North Kumutoto Precinct Project

Section 87F(4) Report

Wellington City Council
Ryan O'Leary

7 April 2015

FIGURE 4 NIWA DATA ON MAXIMUM WIND GUSTS AT 10M HEIGHT AT WELLINGTON AIRPORT ([HTTP://GOO.GL/GLAUBU](http://goo.gl/GLAUBU)) - THESE VALUES ARE LESS THAN HALF THESE RECORDED VALUES AT HEAD HEIGHT: DOTTED LINE, SAFETY CRITERION @ HEAD HEIGHT

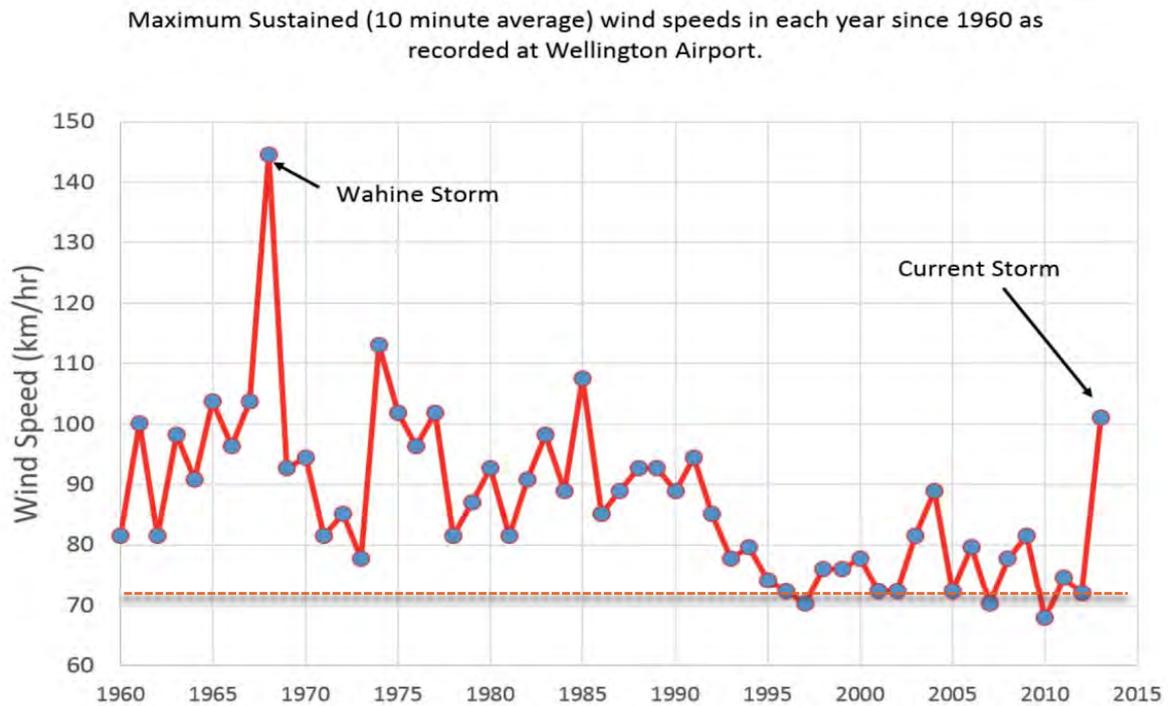
The wind tunnel test report states that around the proposed Site 10 building annual wind gusts at pedestrian height will be experienced within a range of 4m/s to 30m/s (14.4km/hr to 108km/hr). As the force experienced is

proportional to the square of the wind speed, the force at 30m/s is more than twice that of the city's 20m/s safety limit. This is consistent with this area being a notoriously windy part of Wellington. To place these gusts in context, the wind speeds in the open at Wellington Airport are often reported (<http://goo.gl/TEJWYT>) as well above these values (Figure 4). However, even in the open at the airport, a gust at the 10m height of the recording anemometer for weather reports will be more than twice the wind speed experienced at pedestrian height. 150km/hr gusts at 10m at the airport are therefore less than 75km/hr at pedestrian height below the anemometer. The District Plan street level 20m/s gust speed set by the city as its safety limit is 72km/hr at head height.

The area just South of the Railway Station has become significantly more windy in recent years. The pedestrian route along Waterloo Quay on the footpath opposite Site 10, is a critical route for commuters in Wellington because it allows pedestrians to avoid the now well-documented (Figure 5) problems of walking Featherston Street in a Northerly. The number of positions in the neighbourhood experiencing the wind gust speeds reported in the wind tunnel test confirm the match between risk of danger and the City's safety criterion.

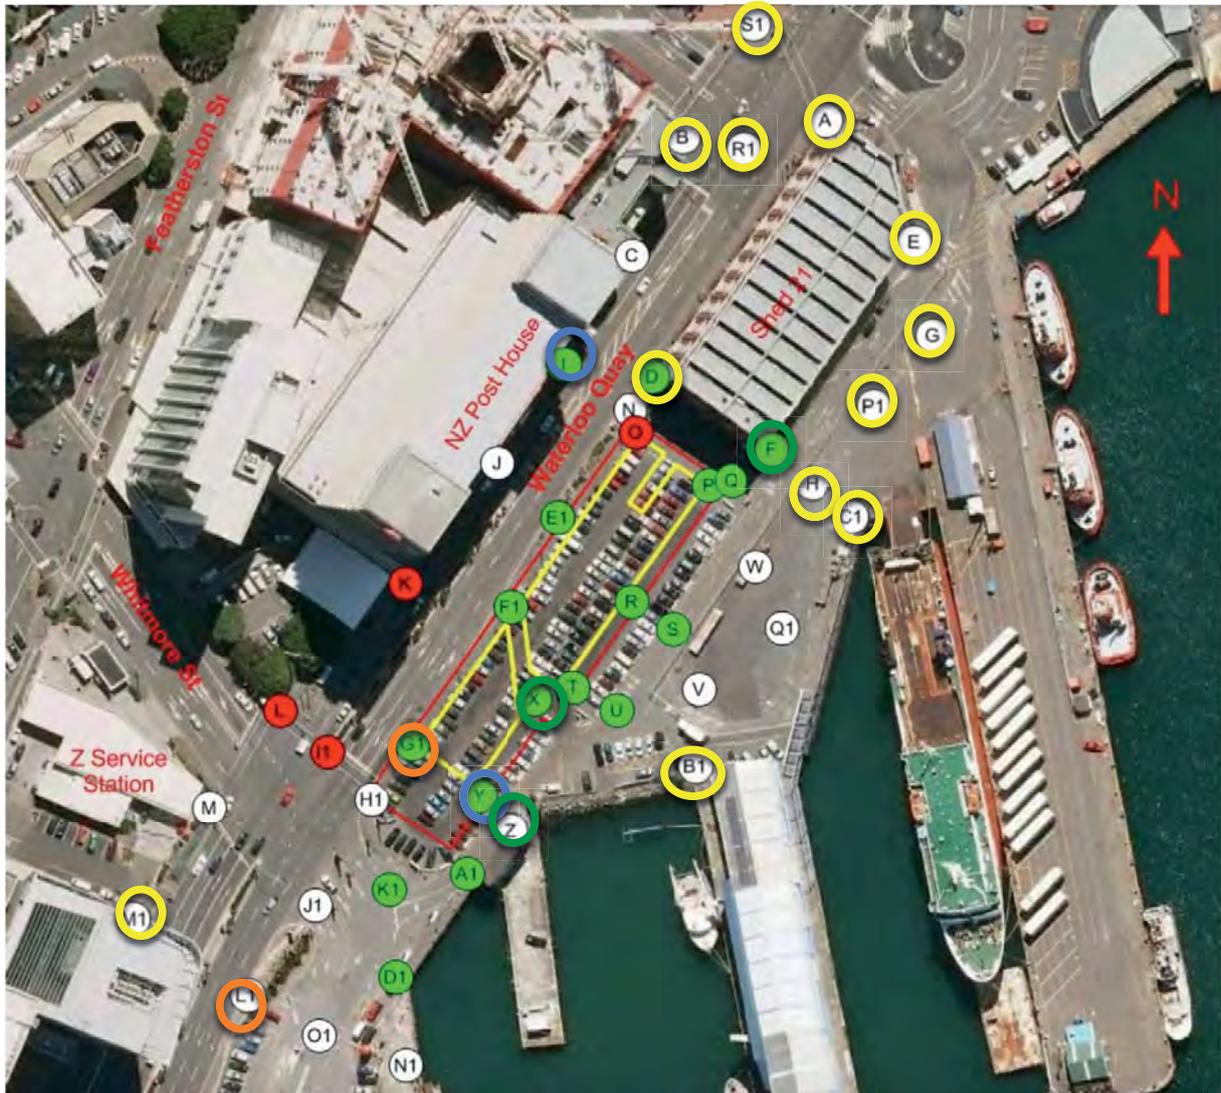
The underlying data summarised in Figure 6 is from the Wind Tunnel test and shows the change in number of days per year for average wind speeds, a measure of the general windiness. The far greater number of green measurement points supports my and the applicant’s general conclusion that placement of the proposed building as a barrier to the wind where there is currently an open car park will improve the overall pedestrian experience, so long as the pedestrian can choose to walk on either the Waterloo Quay or seaward side of the site, depending on the wind direction. This would meet the Cumulative Effect requirement of the District Plan that the “*overall impact of a building on the wind conditions must be neutral or beneficial – WCC DP 13.6.3.5 (c).*”

The concern that must be noted about the wind tunnel test results is that the positions in Figure 6 where the wind speed is shown to be measurably increased are on the other side of Waterloo Quay. These are grouped near the

corner of Whitmore Street and Waterloo Quay and are therefore on one of the most highly used pedestrian routes in Wellington. It is unfortunate that it is the route to use to avoid the Northerly winds in Featherston Street and the wind is increased in Northerly and Southerly winds. It is clear to see that this is a result of the shifting of wind in the street by contrasting the green and orange highlight circles in Figure 6.

Figure 1: Sea level projection for Wellington. Currently on trend for a 1.0 m rise by 2115 [1].

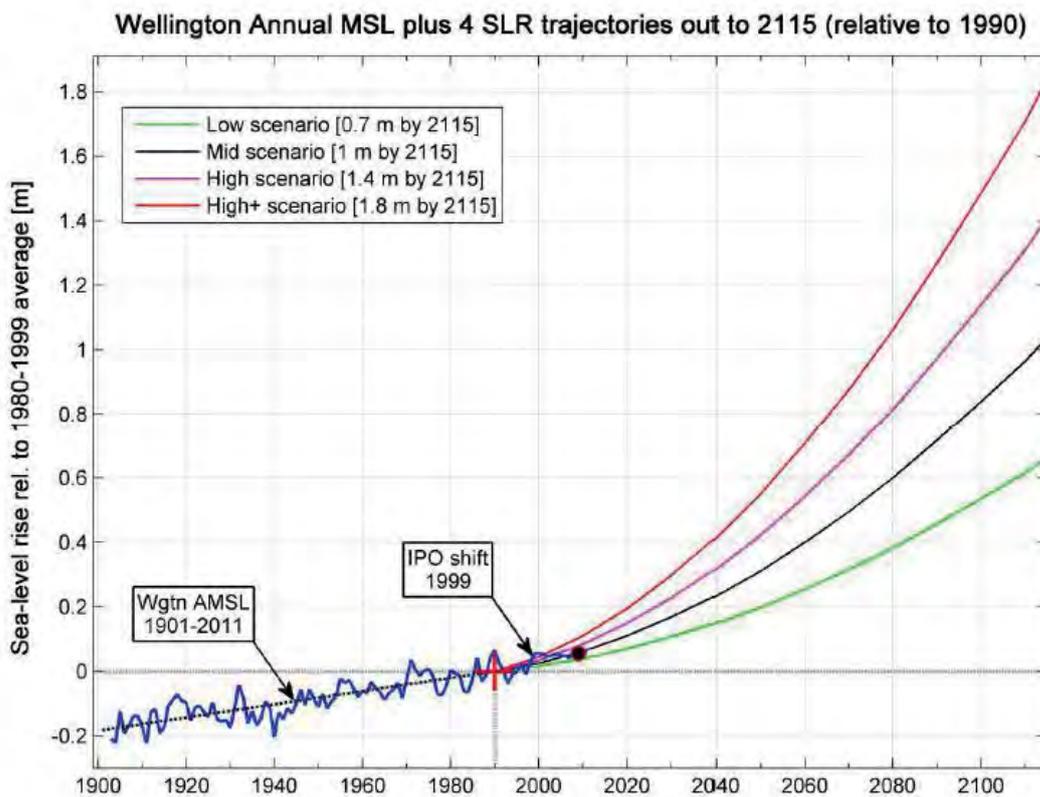
There has been considerable analysis of eustatic sea level trends, both globally and around New Zealand using historical tide gauge data and more recently with remote sensing via satellite altimetry. The long term global average from tide gauges is *ca.* +1.7 mm/yr. More recent satellite altimetry measurements show that since 1993, this rate has increased to 3.1 mm/yr. It is unclear whether this change represents an acceleration in the long term rate, but presently relative sea level at Wellington is tracking toward a rise of 1.0 m by 2115 (Fig 1). The assessment accepts this figure and incorporates it into the ground floor level.
